# Access Compliance Report

## Public Rights-of-Way (Curb Ramps)

Intersection ID: 25199	Main Street: DONNEGAL_FARM_RD	Cross Street: BRIDLE_BROOK_WY	Location: SW
ADA ID: C33475796319	Ramp Type: Perp	Initial Pass/Fail: Fail	Overall Compliance: No
Severity Score: 37.5			
Codes/Mitigation Info/Possible Solution		Field Measurements/Component Compliance

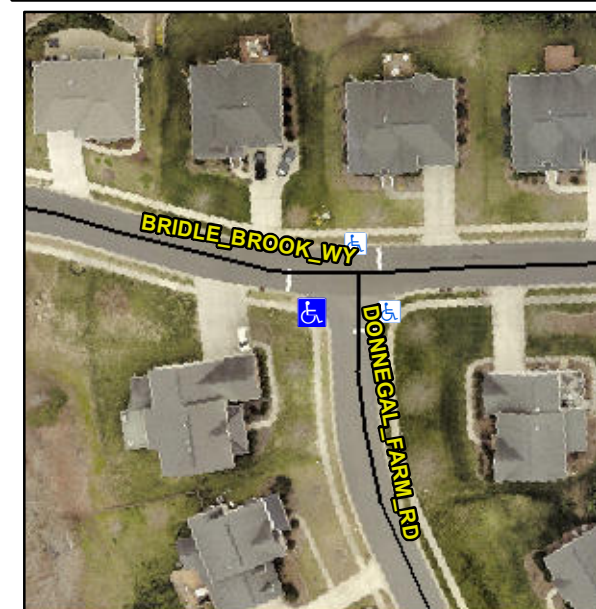
**Not Found, R304.2.2, R304.5.3**

Compliance	Description	Data	Compliance	Description	Data
N/A	Ramp Length (in)	48.0	No	Ramp Slope (%)	10.3
Yes	Ramp Width (in)	48.0	No	Ramp XSlope (%)	8.3
N/A	Flare Type LT	N/A	N/A	Flare Type RT	N/A
N/A	Flare Slope LT (%)	N/A	N/A	Flare Slope RT (%)	N/A
N/A	Flare Traversable LT?	N/A	N/A	Flare Traversable RT?	N/A
N/A	Landing Length (in)	N/A	N/A	DWS Provided?	N/A
N/A	Landing Width (in)	N/A	N/A	DWS Contrast?	N/A
N/A	Landing Slope (%)	N/A	N/A	DWS Length (in)	N/A
N/A	Landing X Slope (%)	N/A	N/A	DWS Full Width?	N/A
N/A	Landing Curb? (Y/N)	N/A	N/A	DWS Offset (in)	N/A
N/A	Shared Landing?	N/A			
N/A	Gutter Ponding?	N/A	N/A	Gutter Slope (%)	N/A
N/A	Gutter Lip Ht (in)	N/A	N/A	Gutter X Slope (%)	N/A
N/A	Painted X Walk1?	No	N/A	Painted X Walk2?	N/A
	X Walk 1 Direction	To E		X Walk 2 Direction	N/A
N/A	X Walk 1 Width (in)	N/A	N/A	X Walk 2 Width (in)	N/A
	X Walk 1 Slope (%)	6.2		X Walk 2 Slope (%)	N/A
	X Walk 1 X Slope (%)	3.5		X Walk 2 X Slope (%)	N/A

**Remove & Replace Entire Ramp.**
